Access Compliance Report

Public Rights-of-Way

(Curb Ramps)

Intersection ID: 50867	Main Street: REAMES_RD	Cross Street: BROOKLINE_RIDGE_DR	Location: W
ADA ID: D0CBAE2E9A51	Ramp Type: Perp	Initial Pass/Fail: Fail	Overall Compliance: No
Severity Score: 10			
Codes/Mitigation Info/Possible Solution		Field Measurements/Component Compliance

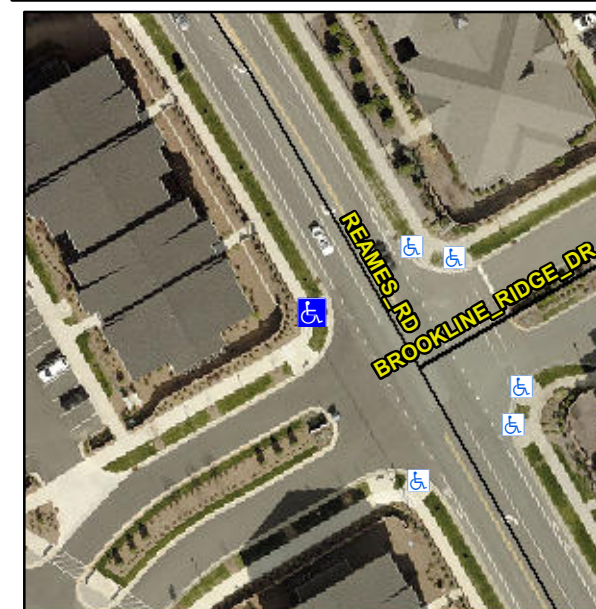
Not Found, R304.5.1, R304.5.3

Compliance	Description	Data	Compliance	Description	Data
N/A	Ramp Length (in)	72.5	Yes	Ramp Slope (%)	8.3
No	Ramp Width (in)	47.0	No	Ramp XSlope (%)	2.1
N/A	Flare Type LT	N/A	N/A	Flare Type RT	N/A
N/A	Flare Slope LT (%)	N/A	N/A	Flare Slope RT (%)	N/A
N/A	Flare Traversable LT?	N/A	N/A	Flare Traversable RT?	N/A
N/A	Landing Length (in)	N/A	N/A	DWS Provided?	N/A
N/A	Landing Width (in)	N/A	N/A	DWS Contrast?	N/A
N/A	Landing Slope (%)	N/A	N/A	DWS Length (in)	N/A
N/A	Landing X Slope (%)	N/A	N/A	DWS Full Width?	N/A
N/A	Landing Curb? (Y/N)	N/A	N/A	DWS Offset (in)	N/A
N/A	Shared Landing?	N/A			
N/A	Gutter Ponding?	N/A	N/A	Gutter Slope (%)	N/A
N/A	Gutter Lip Ht (in)	N/A	N/A	Gutter X Slope (%)	N/A
N/A	Painted X Walk1?	No	N/A	Painted X Walk2?	N/A
	X Walk 1 Direction	To E		X Walk 2 Direction	N/A
N/A	X Walk 1 Width (in)	N/A	N/A	X Walk 2 Width (in)	N/A
	X Walk 1 Slope (%)	1.8		X Walk 2 Slope (%)	N/A
	X Walk 1 X Slope (%)	0.6		X Walk 2 X Slope (%)	N/A

Remove & Replace Entire Ramp.
